# PLAN COMMISSION STAFF REPORT

Agenda Item: PC Docket No. 20-009

**Summary:** Guy Costanza/GM Contracting requesting modifications to the building frontage

at 407-411 Ridge Road.

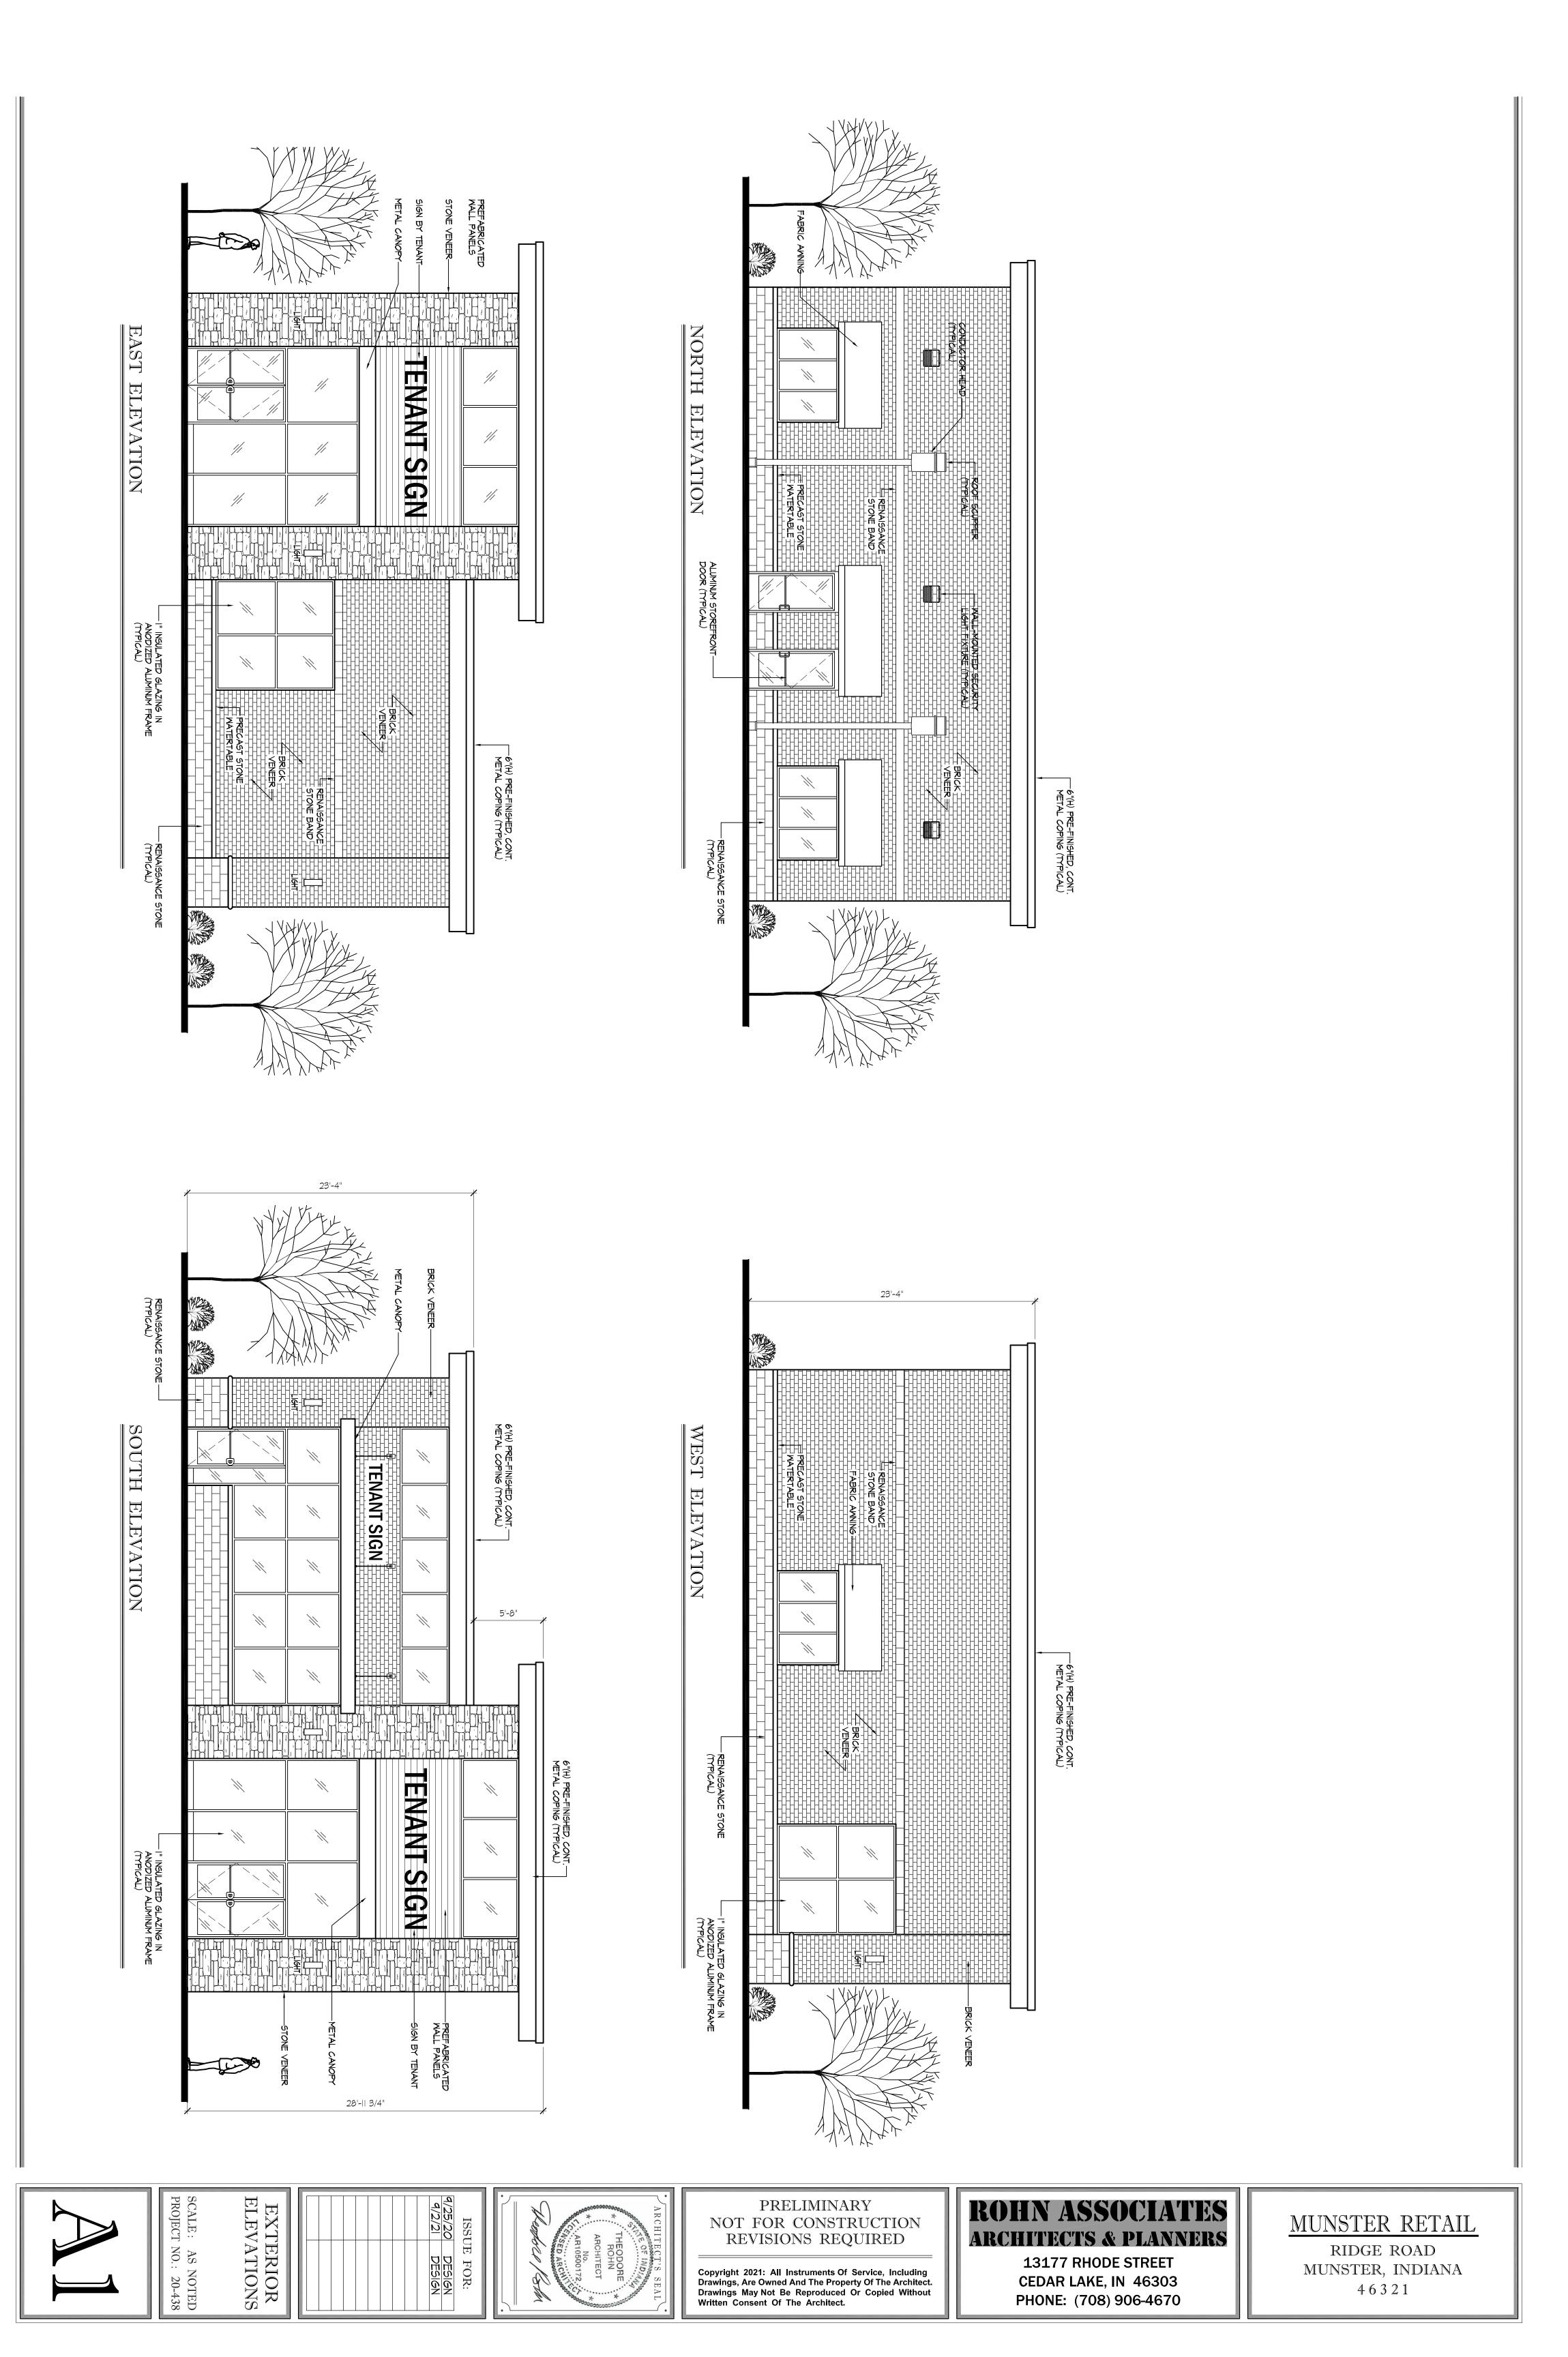
Town staff provided a sketch illustrating the conditions described above, which was then drawn by Torrenga Engineering. It is attached to this memo titled Ridge Café Addition dated 05.06.2022. The previous version of the plan is attached for comparison.
